RESPONSE TO WDEQ COMMENTS ON CAMECO RESOURCES' 2007-2008 ANNUAL REPORT

Selenium Issues Related to Comments 19, 20 and 22

REPORT

April 9, 2010

Figure 3

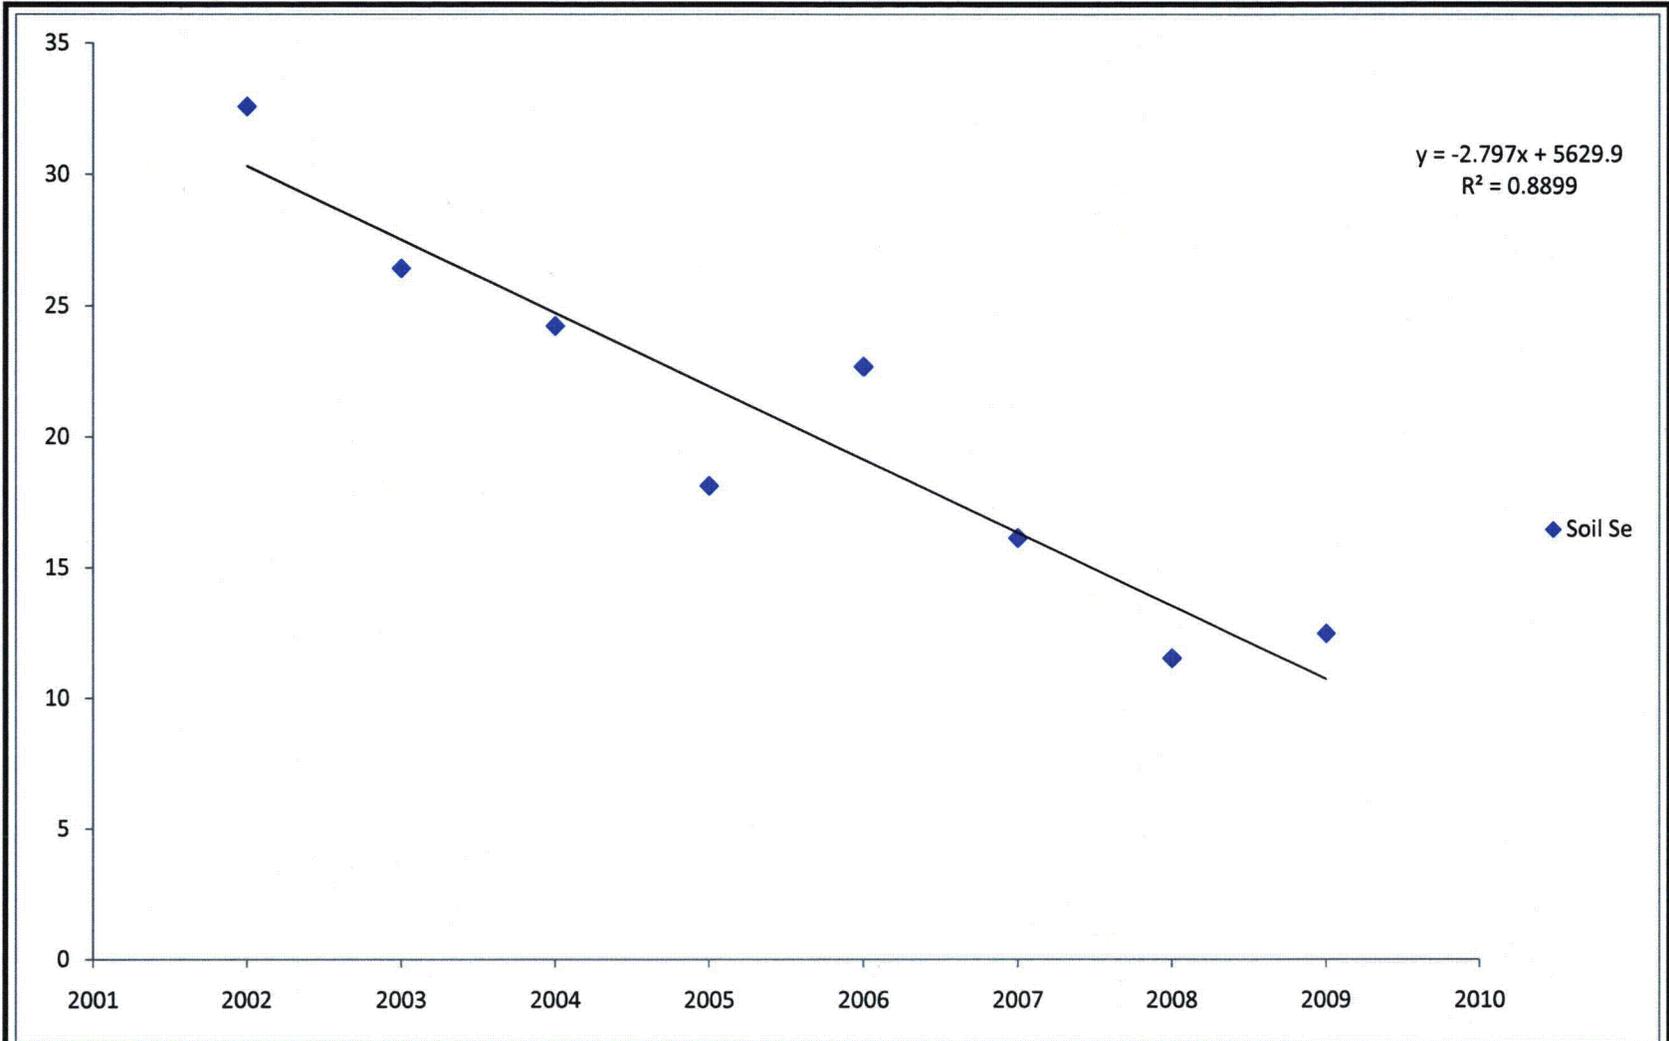
Even though the irrigation areas are fenced during mining, the concern with the livestock is in post-mining conditions. In addition, for birds and small mammals, the concern is both during mining and post mining habitat. How will PRI ensure that the soils and vegetation are suitable for nesting birds and mammals during mining and to grazing and wild life use during the postmine?

For the prospects of post-mining time frames, an analysis of the data suggests the system is capable of moving toward a less plant-available, and therefore less toxic, state for Se. This change is independent of the Se treatment plant or any other active remediation strategies. Irrigation at SAT1 ceased in September 2001 (Bev Johnson, Cameco Resources personal communication). Since that time, the soils at SAT1 have not changed significantly (a non-significant ($p = 0.55$) trend of increasing selenium concentration). Since 2006, the soil concentrations have decreased, though, statistically, this decrease is not significant. Despite no significant changes in Se concentrations within the first 12 inches of the soil profile since the cessation of irrigation, the concentration of Se (mg/kg dry weight) in the vegetation has shown a highly significant ($p=0.0004$) decreasing trend (Figure 3). The change in concentration for the last seven years has been 2.8 mg/kg per year, which would lead to concentrations of Se at or below the generally accepted standard of 5 mg/kg (as cited by Sharmasarkar and Vance 2002) after the year 2011 if current trends continue.

A few of WDEQ's comments ask for a basis that the levels of Se within the vegetation and soil will decrease once irrigation with water containing increased levels of Se ceases. As stated above, the situation at SAT1 gives an empirical basis (Figure 3) that the system should see decreased levels of Se in the vegetation which leads to decreases in the ability to enter the food chain (Ramirez 2000) once irrigation ceases. Although the levels of Se are not appreciably decreasing within the soil profile, the most recent data from the soils at SAT1 and SAT2 show that average soil Se concentrations around what many authors see as a critical level of 0.5 mg Se/kg soil (Figures 2a and 2b). With some more active management as discussed above such as harvesting, soil amendment, intermittent irrigation in post-mine reclamation activities and the introduction of the Se treatment plant, these soil Se concentration levels should begin to decrease. Continued monitoring should verify the efficacy of these management practices.
